Forsyth County Procurement

ADDENDUM #6

RFP 20-78-1620

For: Providing all labor, equipment and materials for the construction of a new Juvenile Justice Center at 875 Lanier 400 Parkway, Cumming, GA 30040. Project includes a multi-phased site development, demolition of existing motel structures and construction of new 62,000 square foot Juvenile Court building.

Sheet No. **S-1.01**
 RELEASED FOR CONSTRUCTION

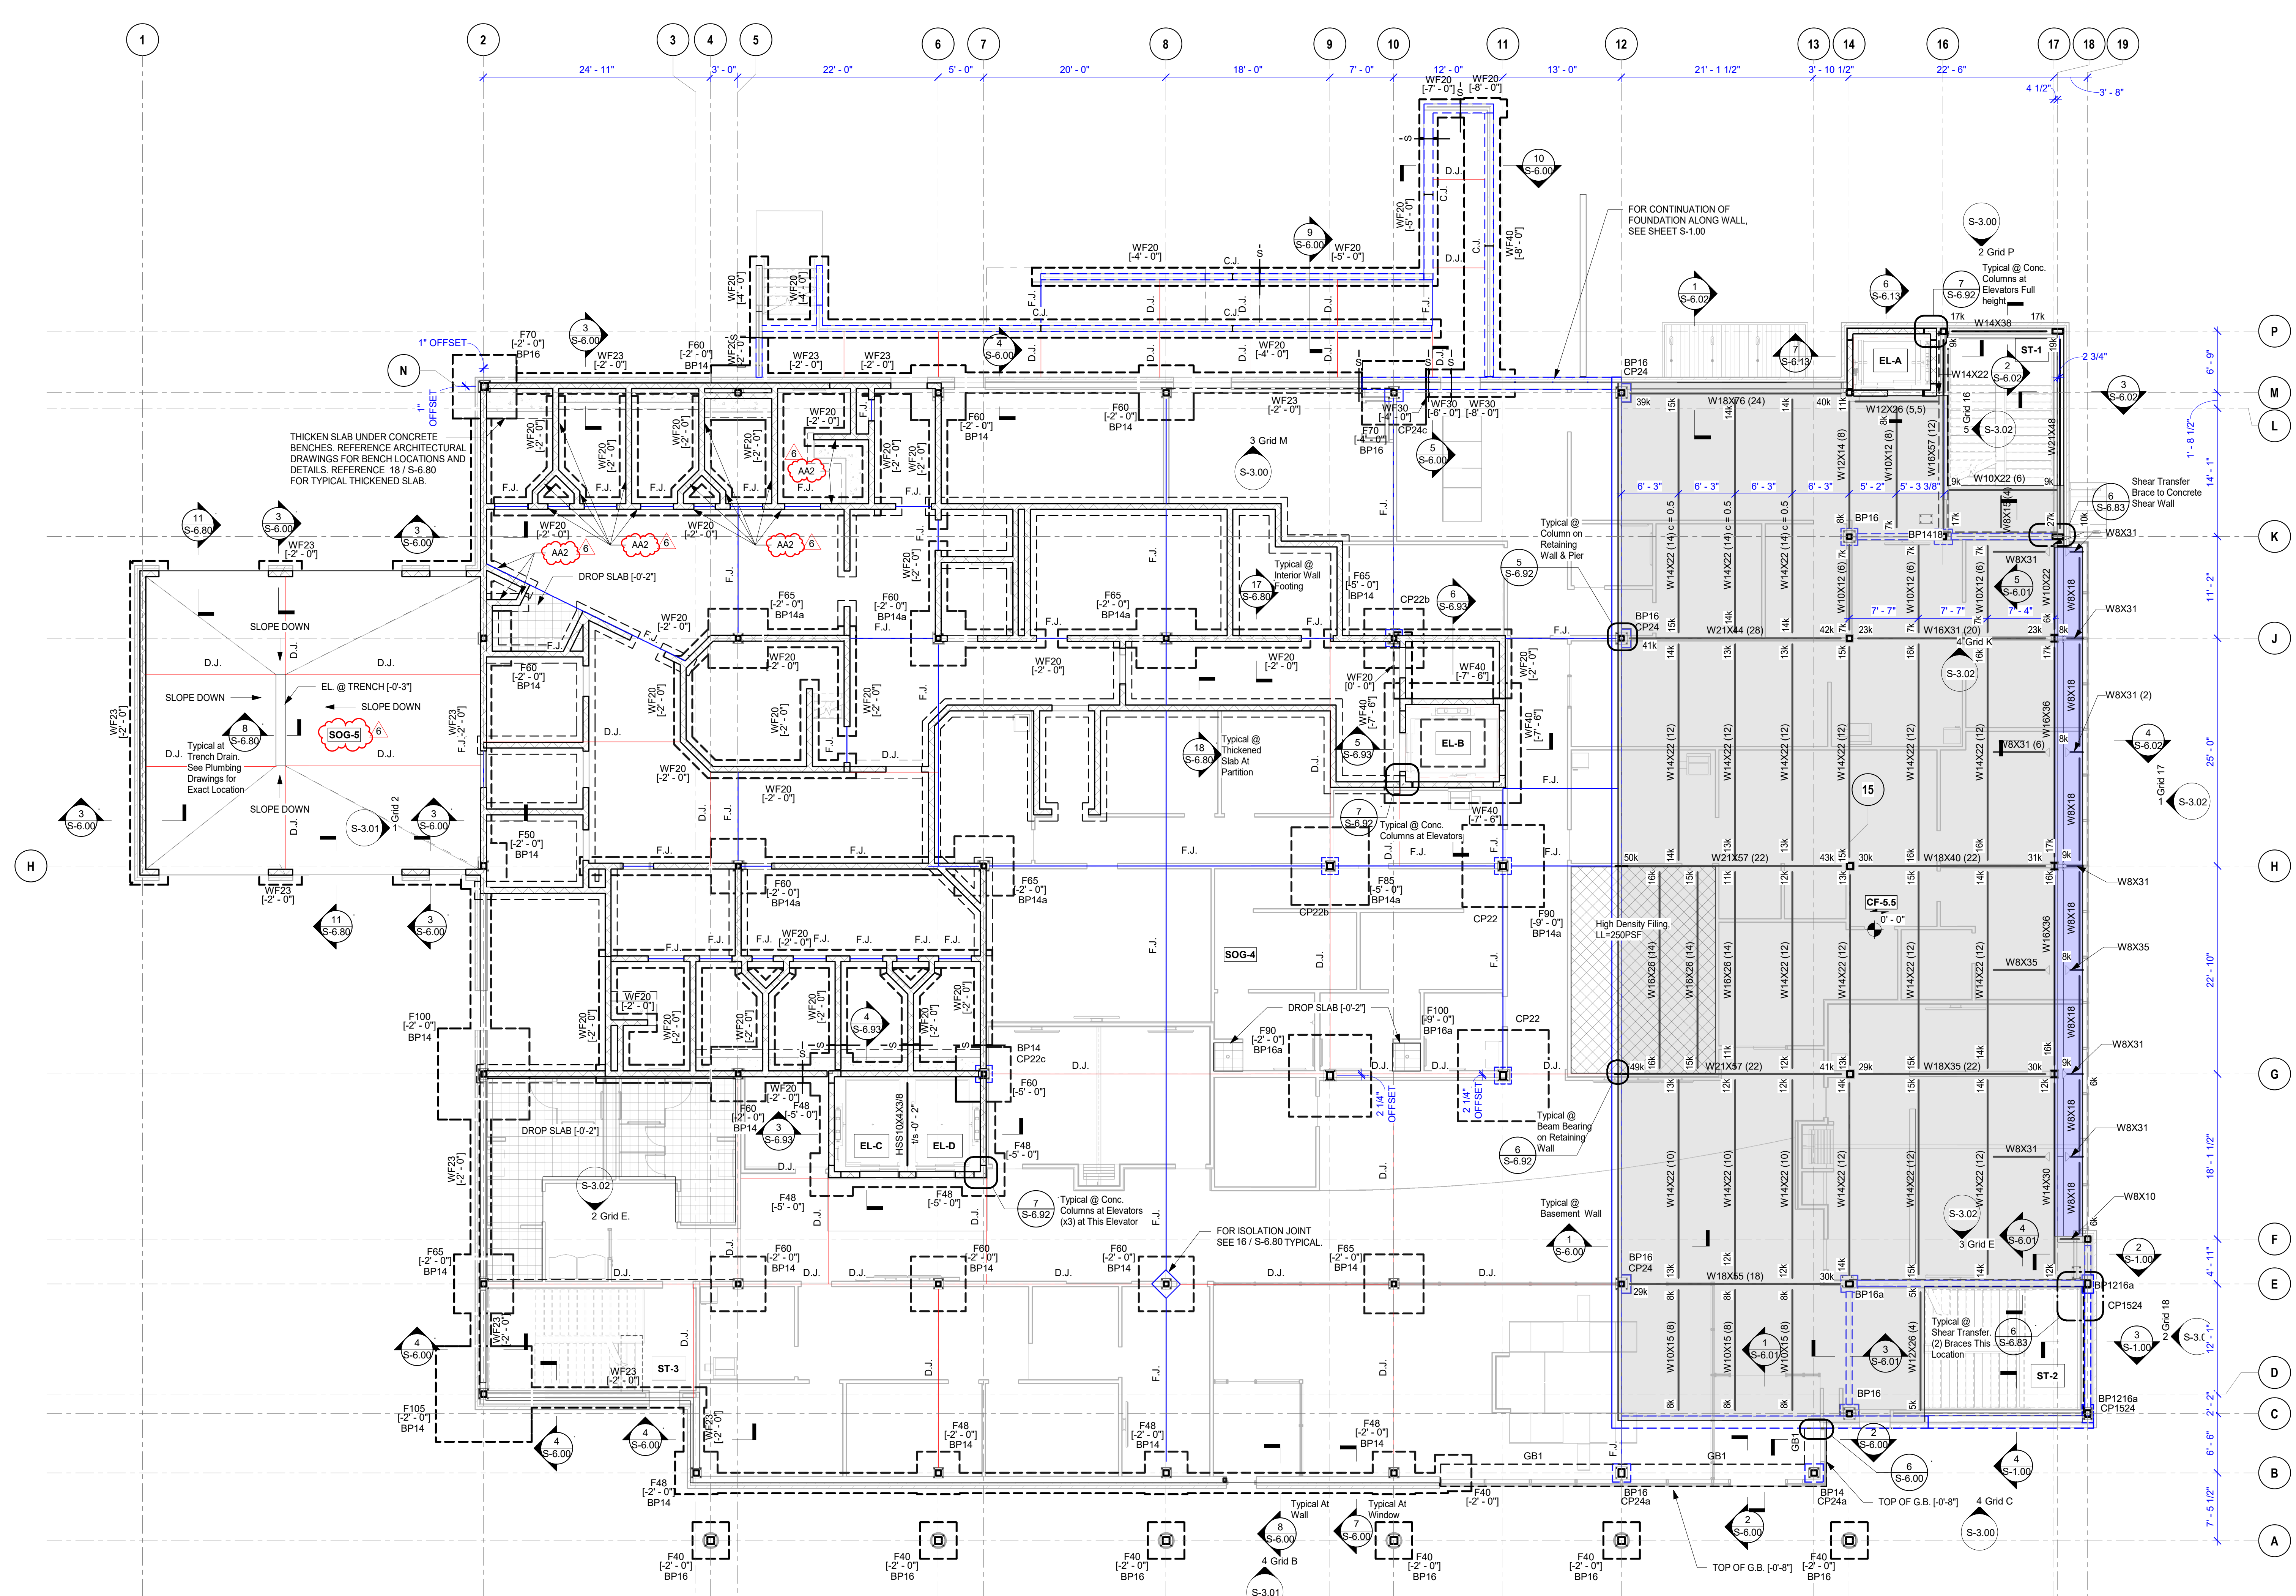
2. Reference sheet S-0.01 GENERAL NOTES revised under addendum #06 dated 07/16/2020.
- 2-6 Sheet S-1.01 LEVEL 100 FRAMING PLAN:
1. Note for Sally-port slab on grade.

2. Added notation regarding alternate 02.
 3. Reference sheet S-1.01 LEVEL 100 FRAMING PLAN revised under addendum #06 dated 07/16/2020.
- 2-7 Sheet A-1.01R LEVEL 100 – REFERENCE FLOOR PLAN:
